**Racine Water and
Wastewater Utilities**

SUBJECT: Change Order No. 4 – Contract W-19-11 – 48-inch Perry to Newman Transmission Water Main

RE: Racine, WI – Spring Street Transmission Water Main – Perry to Newman
Change Order Request – COR 05 - Air Release Assembly

SHEET NO.
DT-01

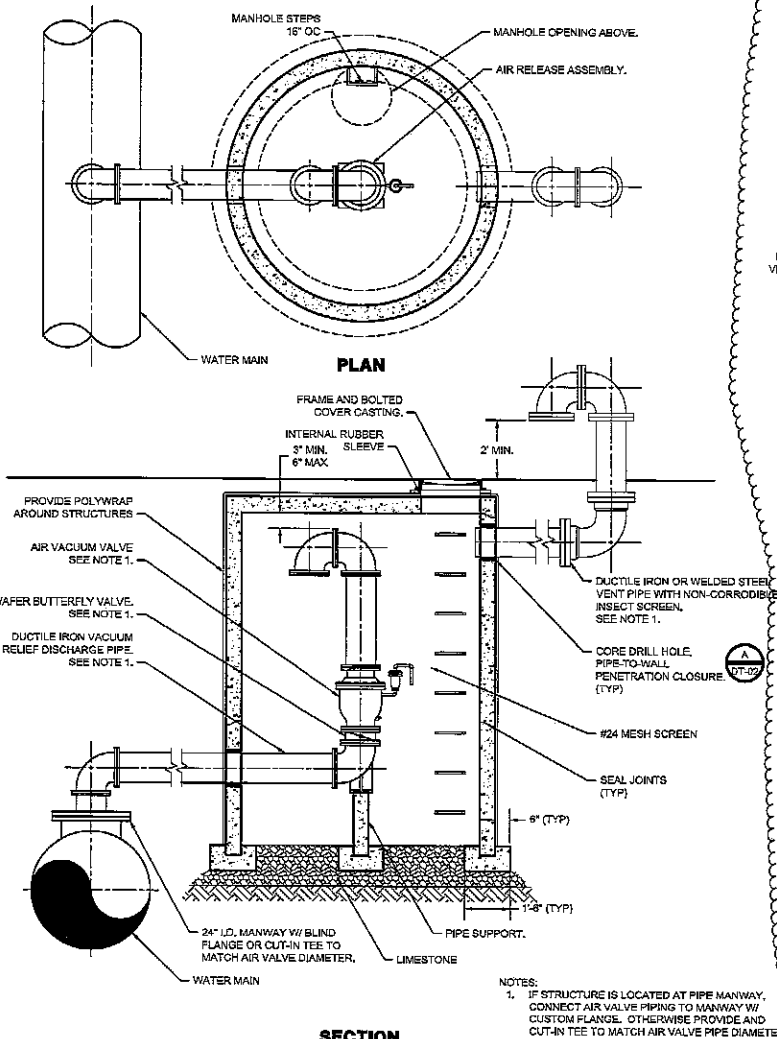
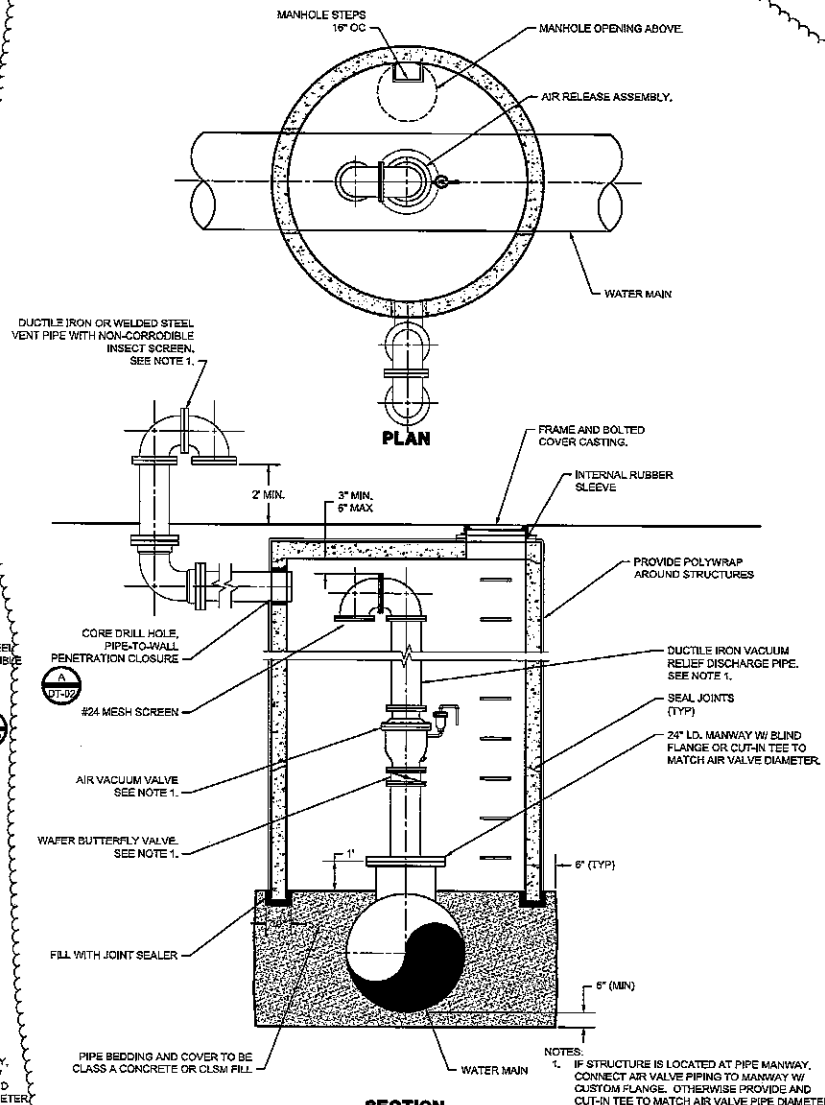
Description: Addition of 9 air vacuum units at high points in the water system.

Reason for Change Order: The addition of the units is needed to avoid pipe collapse in the event of a water main break.

Please consider this letter as a Change Order Request for an adjustment of Contract Price & Time in accordance with Article 11 of the Standard General Conditions. SJ Louis is requesting \$626,000.00 for the labor, equipment & material to install nine (9) Air Vacuum Assemblies per the details supplied by Ruekert & Mielke. SJ Louis anticipates twenty-three (23) working days to complete the installation of the Air Vacuum Assemblies. However, SJ Louis requests an equitable extension of Contract Time for procurement and delivery of materials incorporated in this change. SJ Louis' supplier has stated the Air Valves are approximately 20-34 weeks from approved submittal.

2. Air vacuum valves to be either Val-Matic 150 SF Series with attached air release valve (combination type), or APCO Series 1800/1100A (combination type). Each valve to contain discharge pipe with gooseneck instead of protector hood. Air release valve orifice size to be 0.75 inches for all assemblies.

3. Single-valve type structures and dual-valve type structures may be substituted for each other at Contractor's request upon Engineer's approval.
